## Public Input No. 59-NFPA 101-2021 [ Section No. 18.2.2.2.4 ]

**Submitter Full Name:** Adam Graybeal  
**Organization:** Koffel Compliance LLC  
**Street Address:**  
**City:**  
**State:**  
**Zip:**  
**Submittal Date:** Mon Apr 12 14:15:10 EDT 2021  
**Committee:** SAF-HEA

**Figure A.18.2.5.7.2.1(B)(a) All Sleeping Rooms Provided Either with Direct Supervision by Staff or Smoke Detection.**

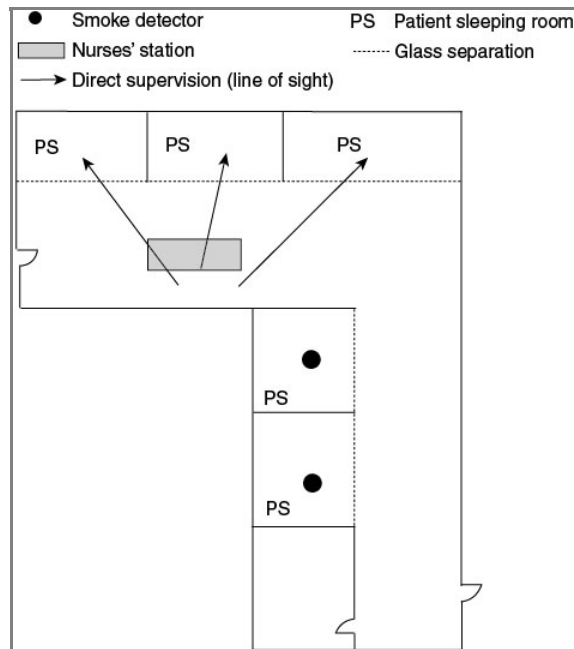
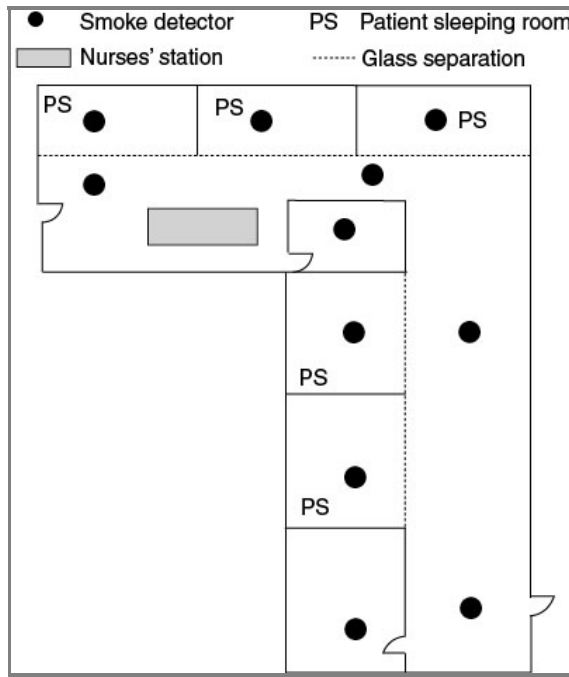
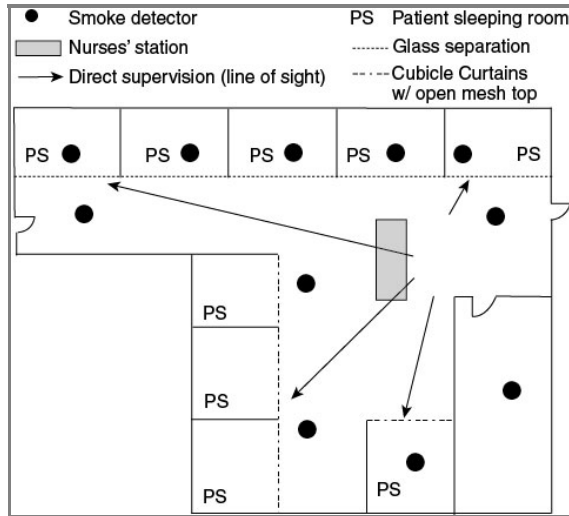
This Public Input is submitted by the Health Care Occupancies Task Group on Nurse's Stations. The task group recommends deletion of 18.2.5.7.2.1(B), in which case the Annex note needs to be deleted as well. Note that the figures address situations in which either supervision or smoke detection is required, but not both. The task group recommends eliminating this situation from Chapter 18, requiring either smoke detection or both smoke detection and supervision, depending on the suite size. No change to Chapter 19 is proposed, so the figures will be needed in the Annex note to 19.2.5.7.2.1(B).
